Technical Service Bulletin: TSB210013	Released Date: 05-Feb-2021
C500 D6RE Fault Code 5866 Harness Fix

C500 D6RE Fault Code 5866 Harness Fix

Figure 1, New routing of CC4D-3 Wire

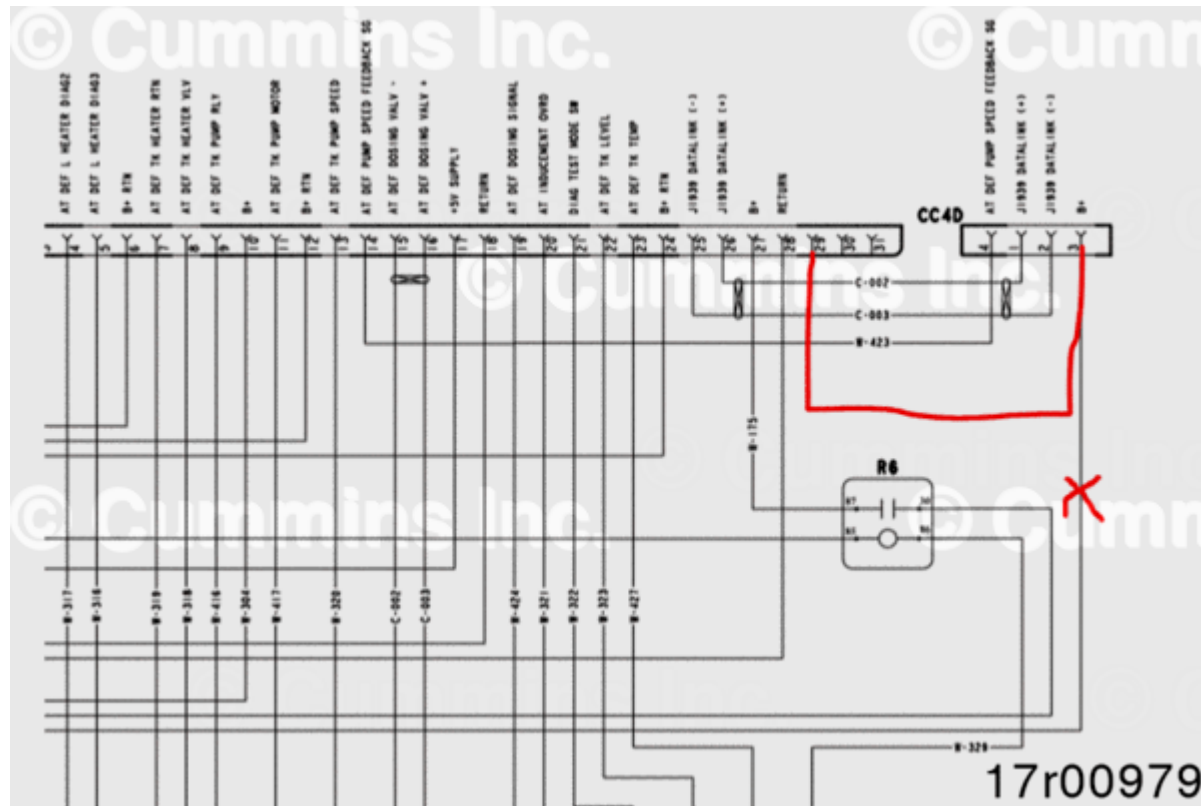
1. Install updated enclosure wiring harness from enclosure supplier, Girtz Industries.
 - 1 a. This fix only applies if this updated harness has been installed.
2. Reroute wire from P61 pin 29 to CC4D pin 3 on harness A064J490

Figure 2, Identification of Connectors P61 and CC4D

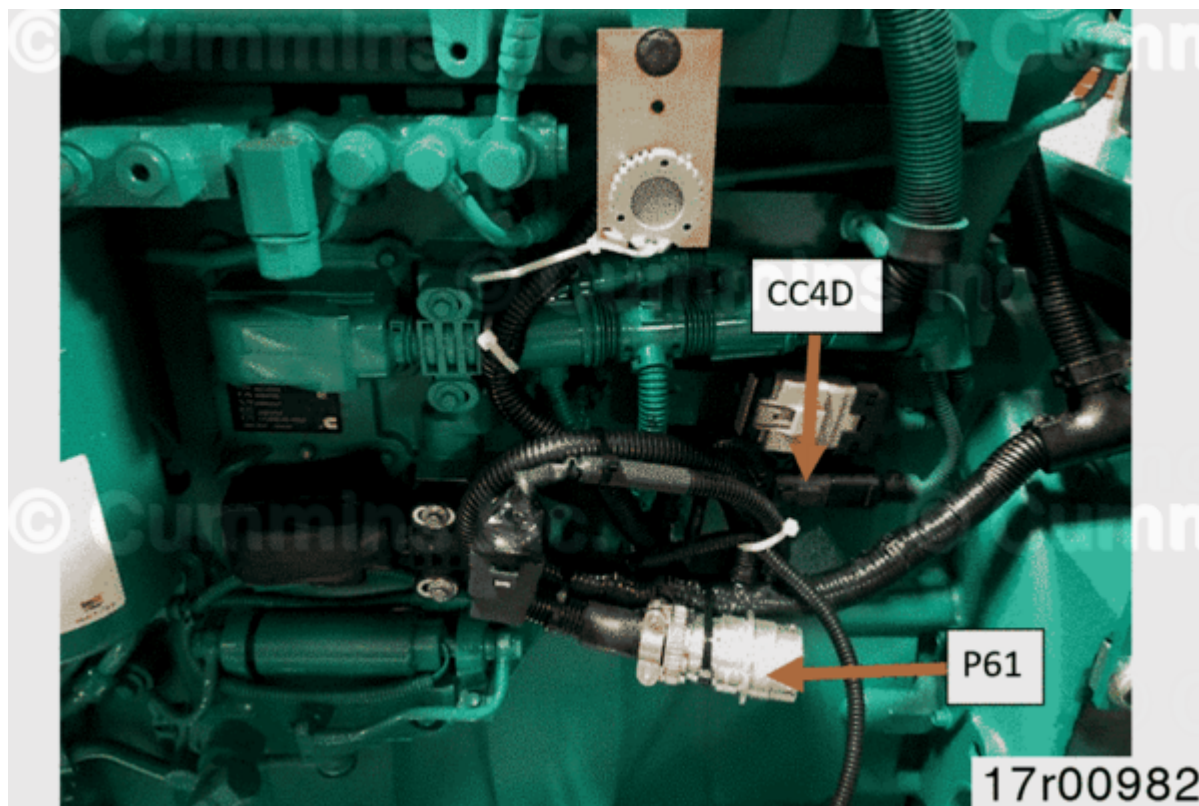
2 a. Identify Connector CC4D and Connector P61

Figure 3, Approximate location of SP23 on Harness A064J490

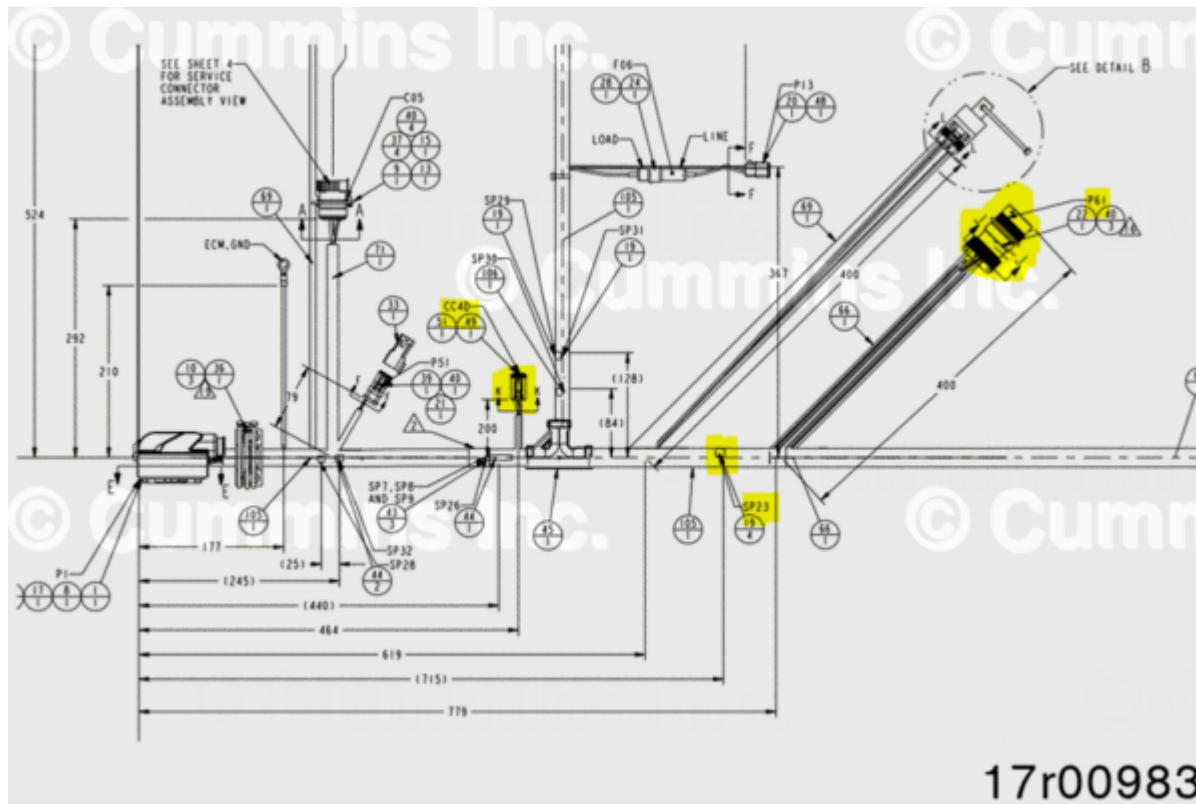
2 b. Cut the wire leaving from CC4D-3 close to splice SP23-2.

- 2 c. Tape and secure exposed wire end from SP23-2 to prevent shorting
- 2 d. Route wire from CC4D-3 into P61-29, extend as necessary
- 2 d i. Use butt-splice connector to extend clipped wire from CC4D-3
- 2 d ii. Use size 18 AWG wire to extend to reach P61-29
- 2 d iii. Use a size 16 pin inside the P61 connector body (pin Part Number 0323-1492)
- 2 e. Install the extended wire with pin into P61-29
3. The fault code 5866 will no longer be active if the fix has been properly identified.
